FIELD CHANGE ORDER	NUMBER: LG02-F003
--------------------	-------------------

APPLIC: All Models of the LG02 printer may be upgraded with this FCO. Customers whose systems exhibit one or more of the problems stated below in the PROB/SYMPT section will require this upgrade.

FCO LG02-F003

FIGURE 1

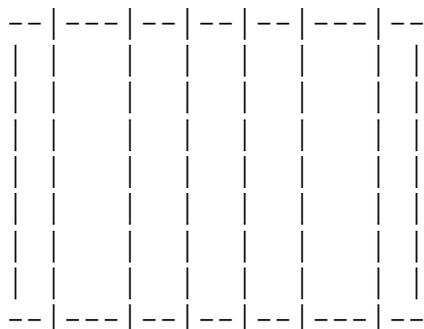
4) Remove the CPU PCB from the card-cage as follows:

- o Locate the CPU PCB. (See Figure 1)
- o Grasp the CPU PCB by the locking tabs (ejectors) at the top and bottom, lift the ejectors away from the PCB and pull the PCB free from the card-cage.

6) Remove the I/O Control PCB from the card-cage as follows:

- o Locate the I/O Control PCB in the card-cage. (See Figure 1)
- o Grasp the I/O Control PCB by the locking tabs (ejectors) at the top and bottom, lift the ejectors away from the PCB and pull the PCB free from the card cage.

5) Install the new CPU PCB

- o Remove the Control PCB (29-26617-00) from the EQ kit.
- o Grasp the Control PCB at the top and bottom and carefully slide it into the card cage.
- o Press the CPU PCB into the backplane and close the ejectors.

7) Install the new I/O Control PCB as follows:

- o Remove the I/O Control PCB (29-26154-00) from the EQ kit.
- o Grasp the PCB at the top and bottom, and carefully slide it into the slot where the old one was removed.
- o Press the PCB into the backplane, and close the ejectors.
